**Symptom in Vehicle Interior - Ignition Starter Switch Jammed in Dashboard Trim Panel:  
Installing Washers (SY 155/19)**

Model line: **Cayenne (9YA/9YB)**

Model Year: **As of 2019 up to 2020**

Subject: **Ignition starter switch**

*Ignition starter switch*

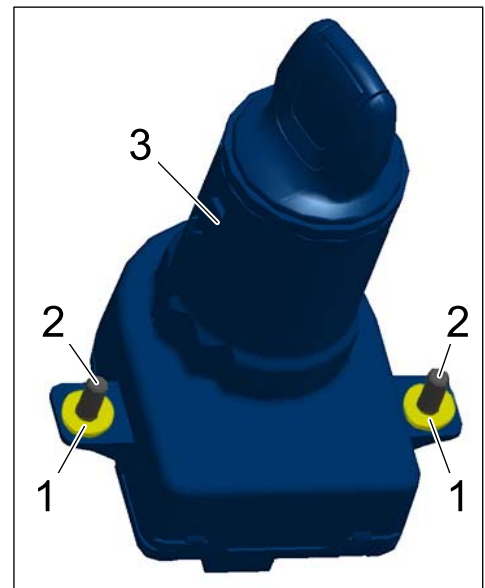
Work Procedure: 1 Remove ignition starter switch ⇒ *Ignition starter switch -1-* from dashboard trim panel on driver's side ⇒ *Ignition starter switch -2-*.

1.1 Unscrew and remove screws ⇒ *Ignition starter switch -3-*.

1.2 Guide ignition starter switch ⇒ *Ignition starter switch -1-* out of dashboard trim panel on driver's side ⇒ *Ignition starter switch -2-*.

*Washers*

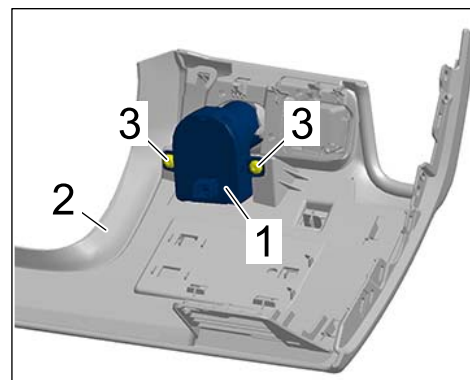
- 2 Position washers ⇒ *Washers -1-*.
  - 2.1 Install screws ⇒ *Washers -2-* on ignition starter switch ⇒ *Washers -3-*.
  - 2.2 Position washers ⇒ *Washers -1-*.

Remedial Action: Install washers between ignition starter switch and dashboard trim panel on driver's side.
